Planning & Zoning Board

Thursday, November 7, 2024

Summit Crossing – Major Site Plan, Preliminary Plat, Variance Requests

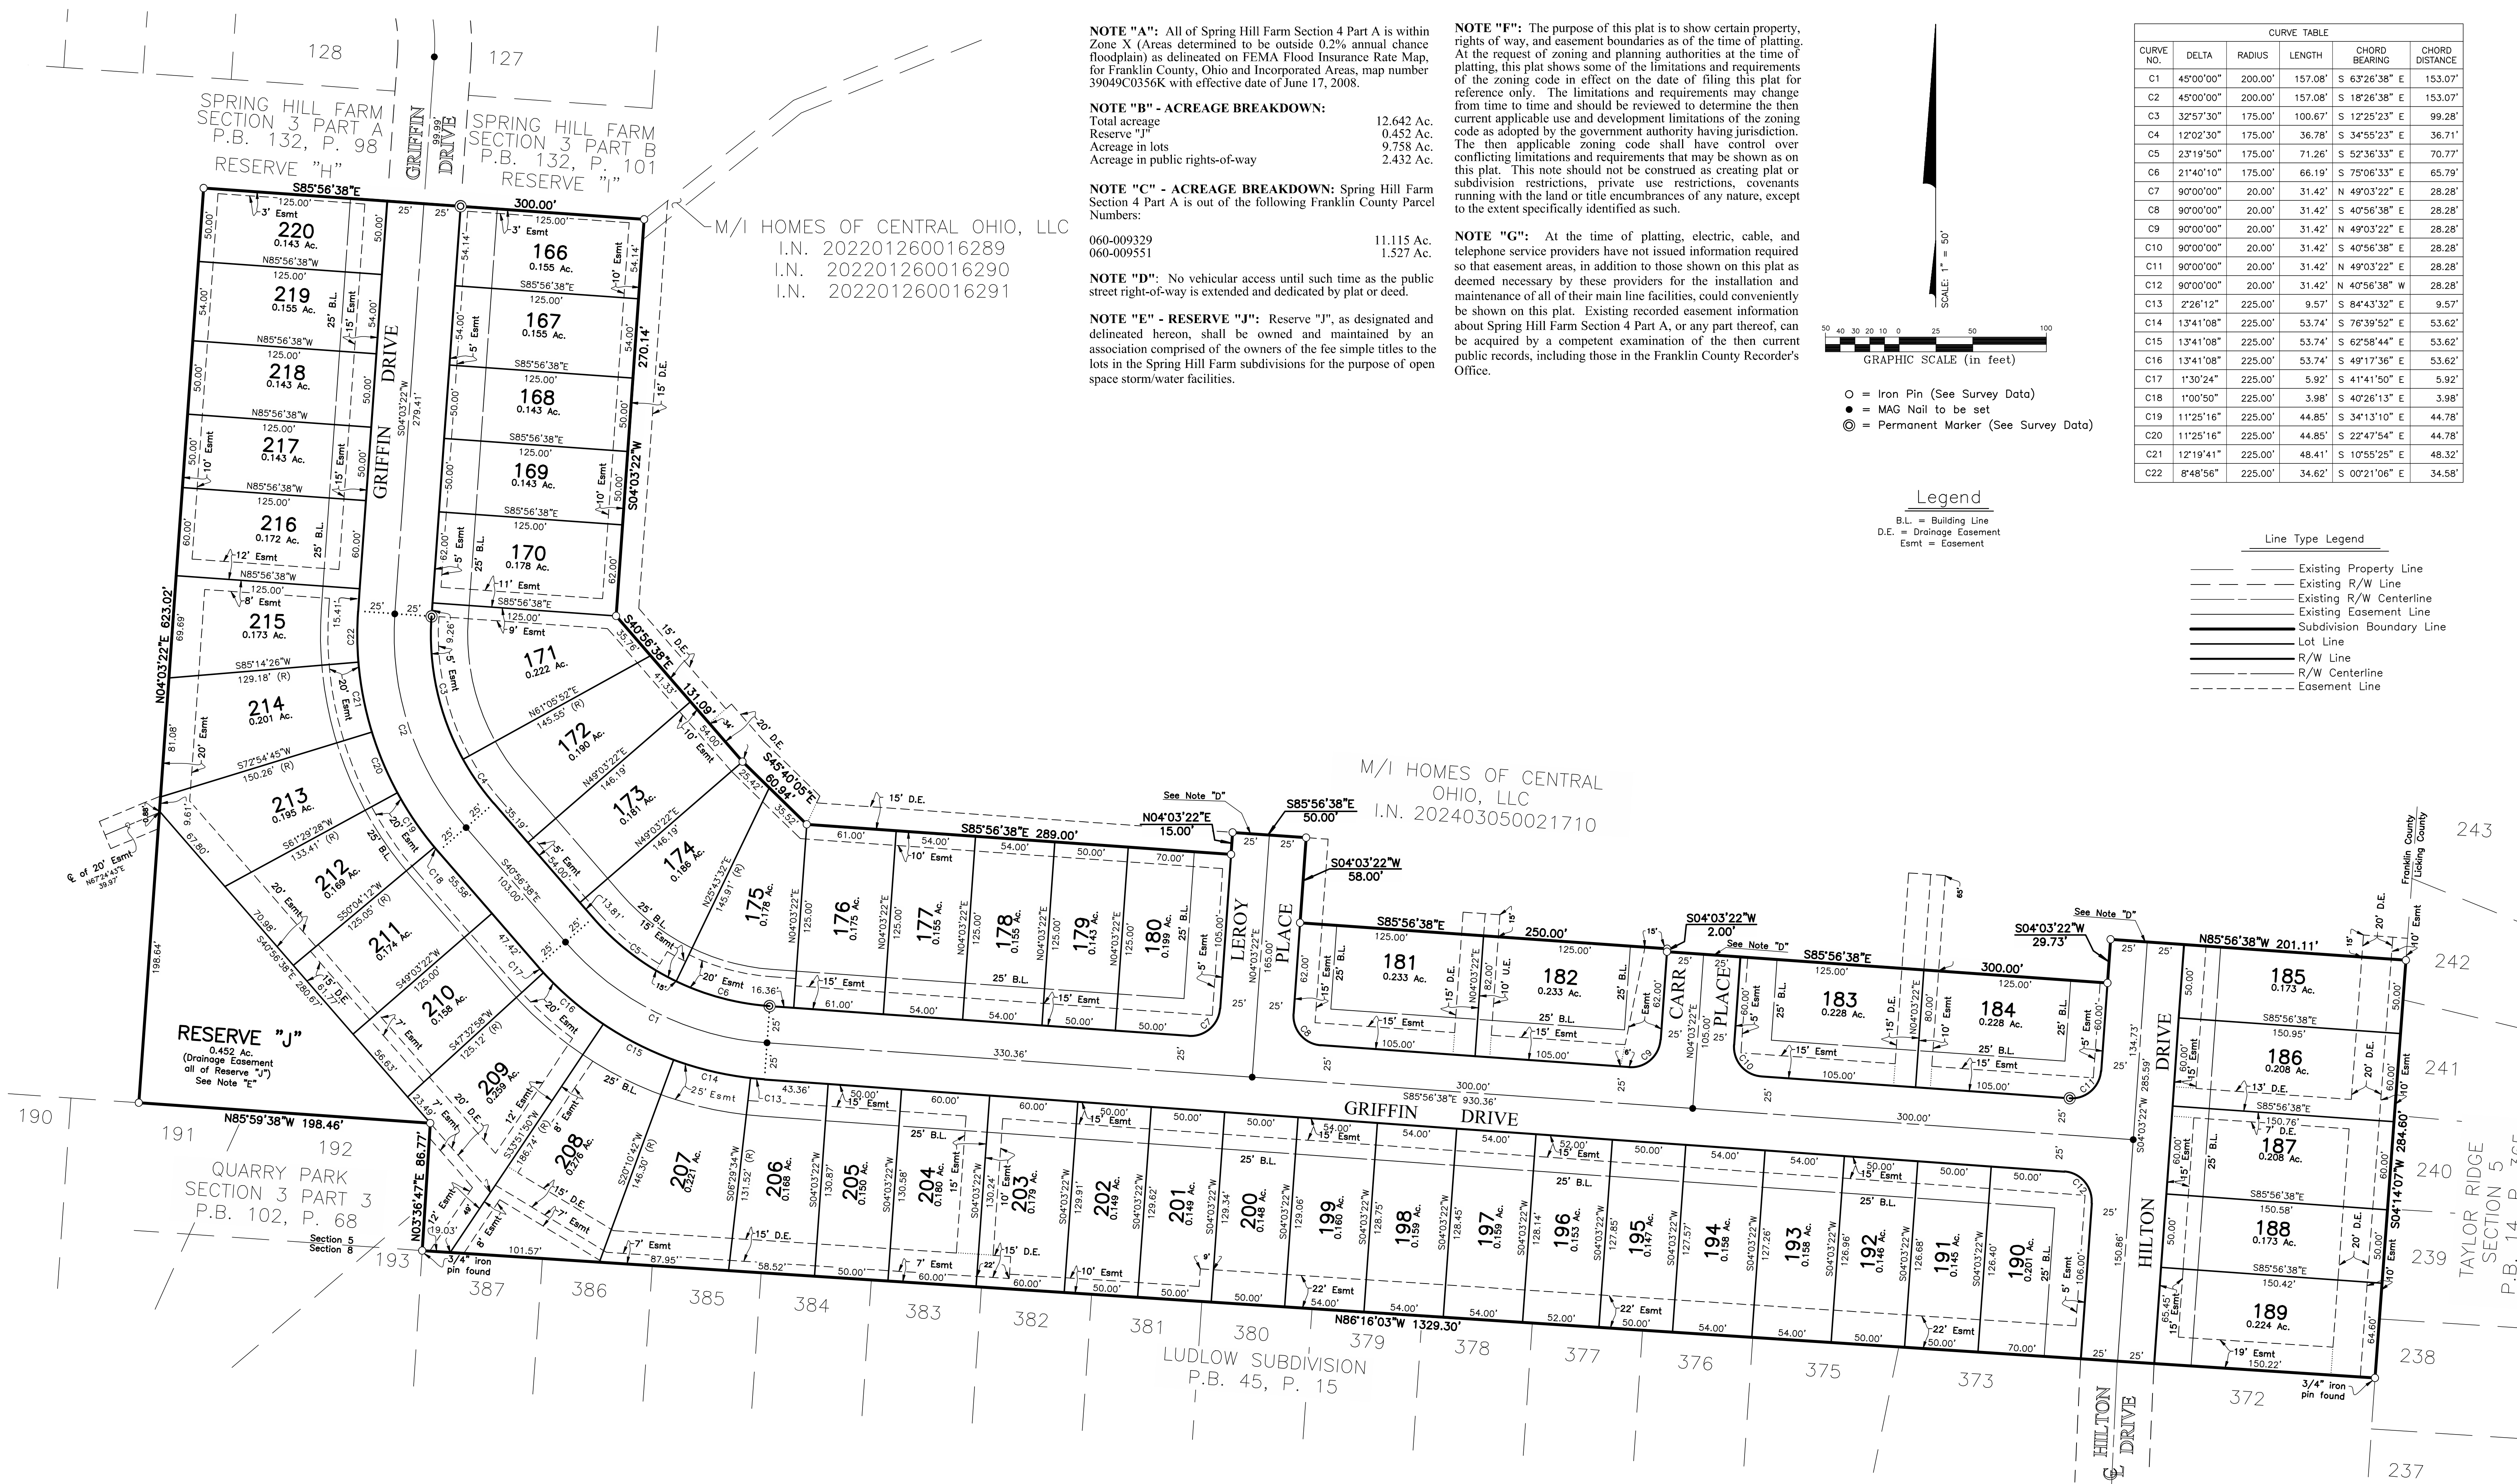
- a. Sheet 2 of 2: Identifies a 20-foot-wide easement onto Spring Hill Farm Section 3 Part A, PB 132, P 98. Please ensure this easement exists on Section 3 plat and does not require replatting. **Item has been addressed**

- b. Sheet 2 of 2: Drainage Easements are shown around perimeter and fall outside of the platted areas. **Item has been addressed**
- c. Sheet 2 of 2: Please provide legend of symbols for monument, iron pin, mag nail, etc, on this sheet as well. **Item has been addressed**

- f. On sheet 1 of 2: revise the signature line for “Charman, Planning Commission” to “Chairman, Planning and Zoning Board”. **Item has been addressed**

- g. On sheet 1 of 2: Add a signature line for the “Director of Public Service”. **Item has been addressed**

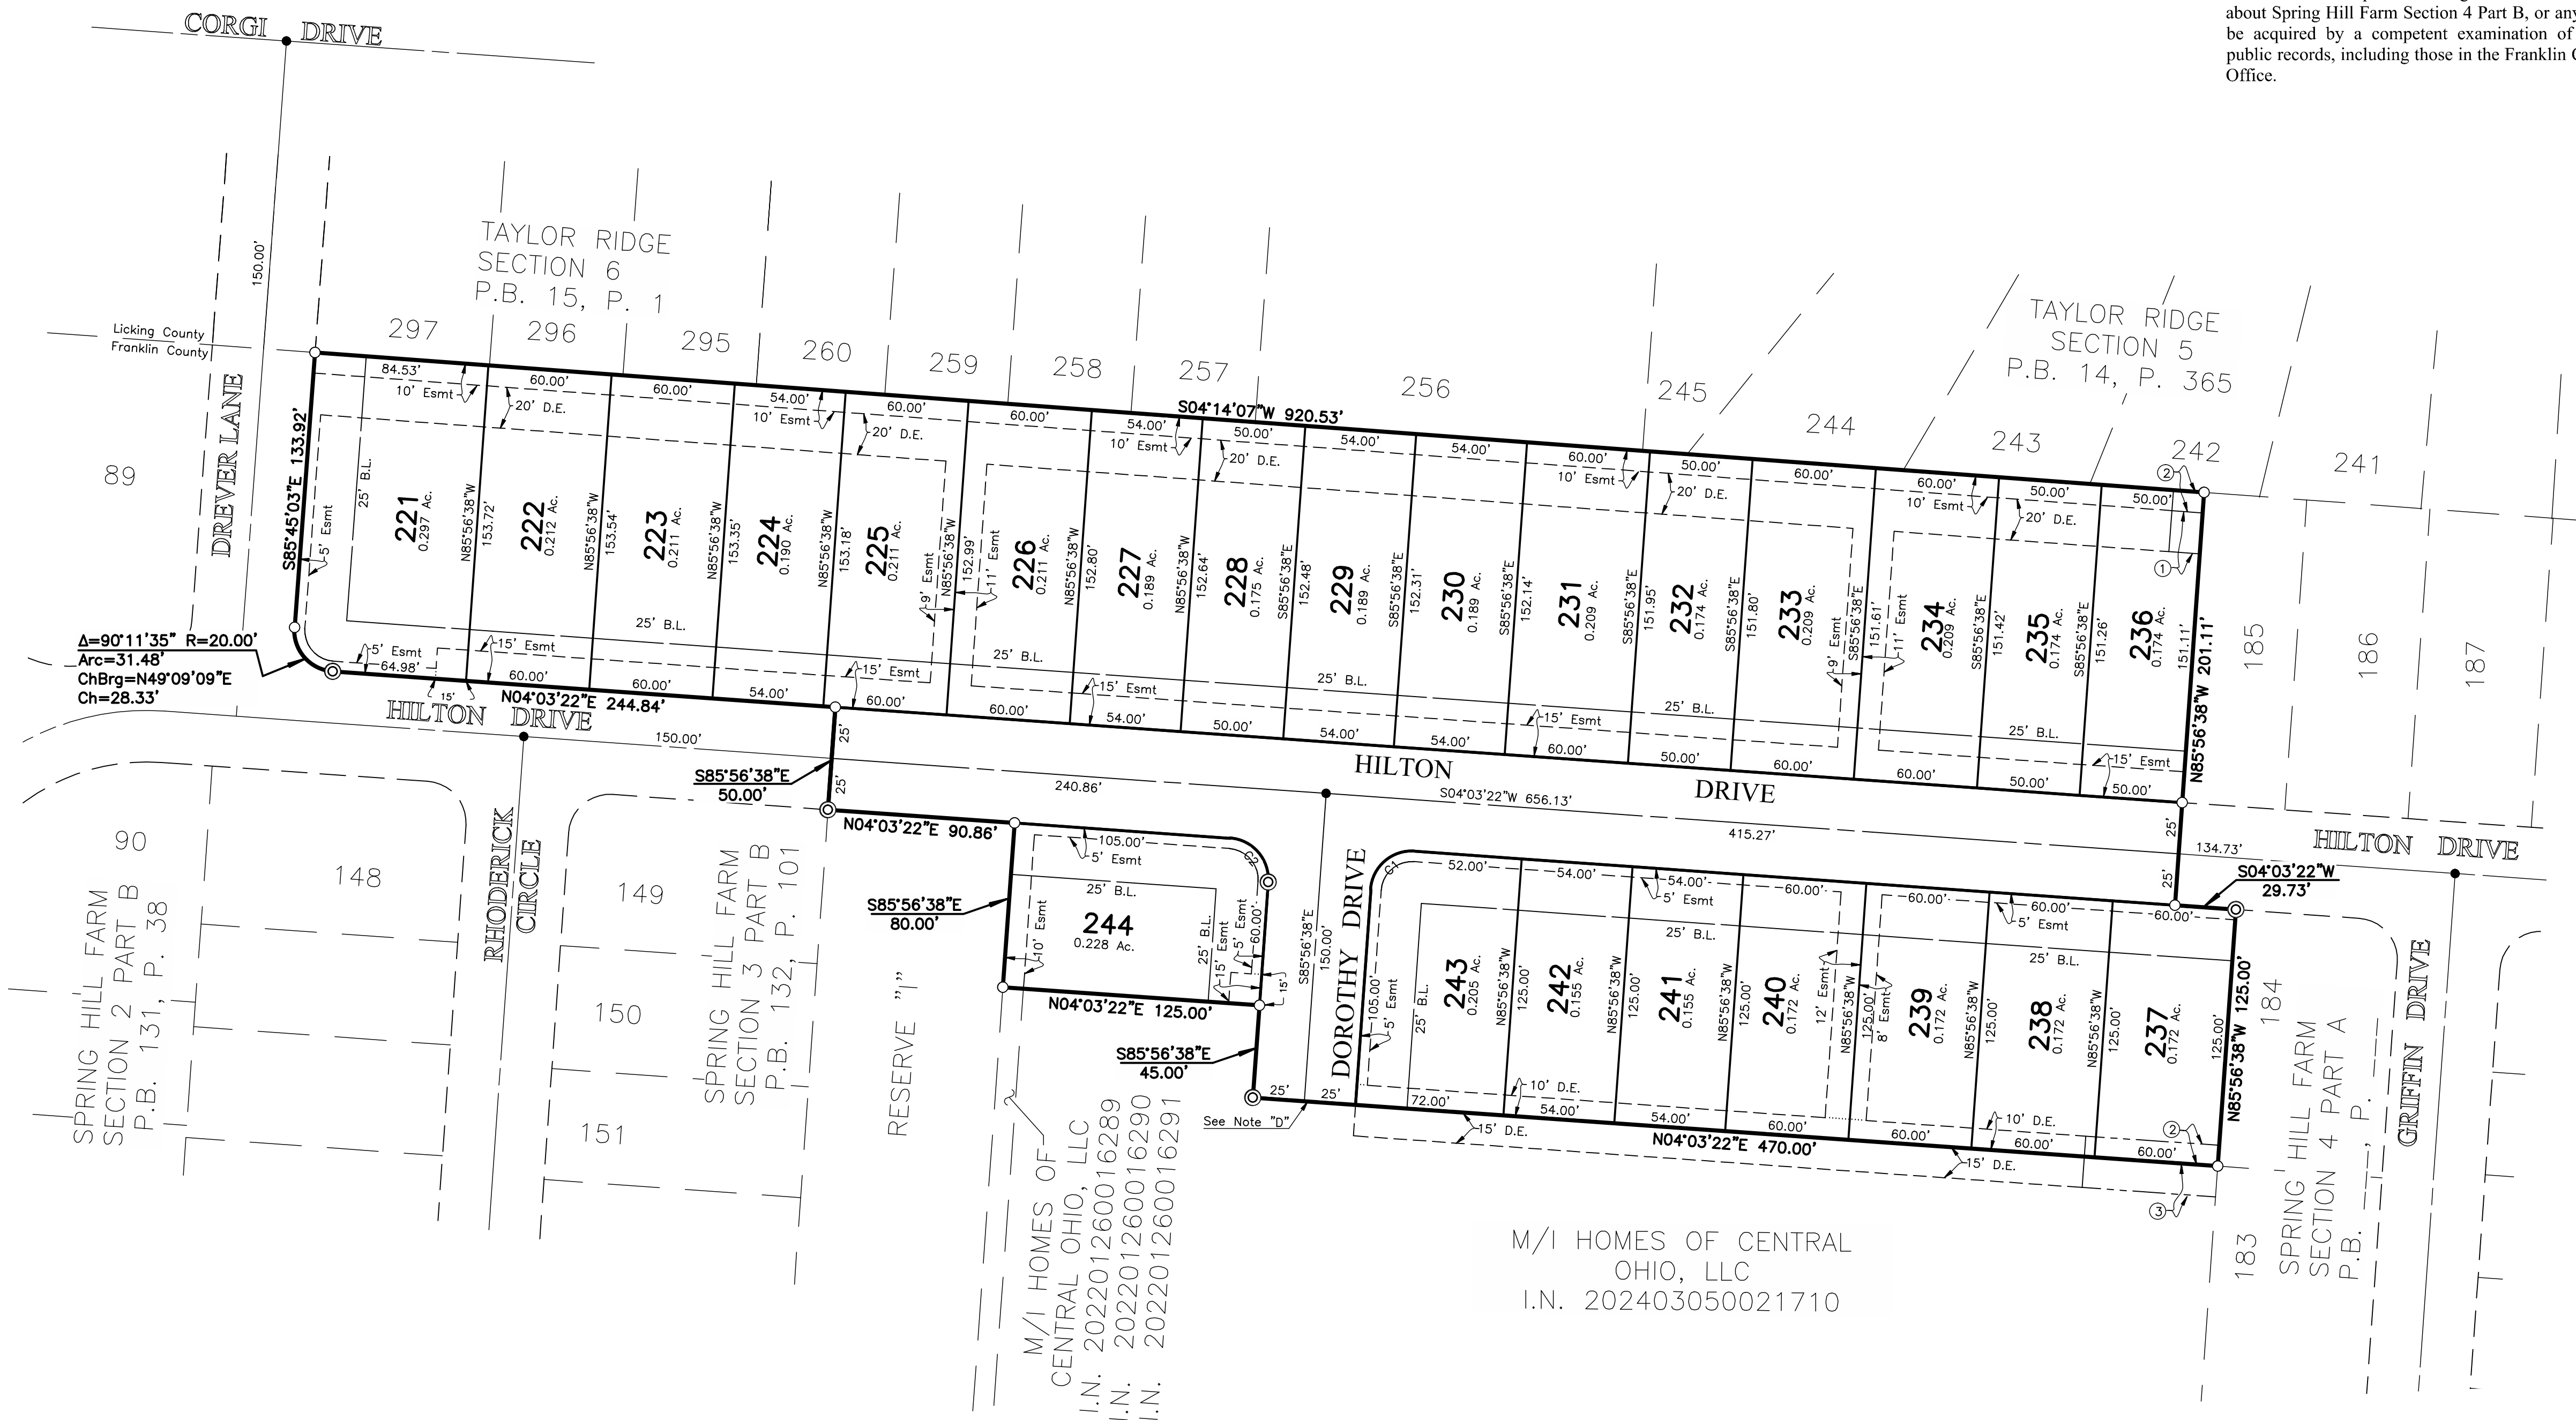
- a. Sheet 1 of 2: This sheet states the Plat is for 9.554 +/- acres, while sheet 2 states 5.554 +/- acres. Please revise the incorrect sheet. **CORRECTED TO 5.554 +/- acres.**
- b. Sheet 2 of 2: Please provide legend of symbols for monument, iron pin, mag nail, etc, on this sheet as well. **Item has been addressed.**
- c. The applicant is seeking final plat approval for Spring Hill Farm Section 4 Part B.
- d. The lot dimensions, rights-of way, layout, setbacks, and open space configuration appear to be consistent with the approved major site plan and preliminary plat.
- e. On sheet 1 of 2: revise the signature line for "Charman, Planning Commission" to "Chairman, Planning and Zoning Board". **Item has been addressed.**
- f. On sheet 1 of 2: Add a signature line for the "Director of Public Service". **Item has been addressed.**
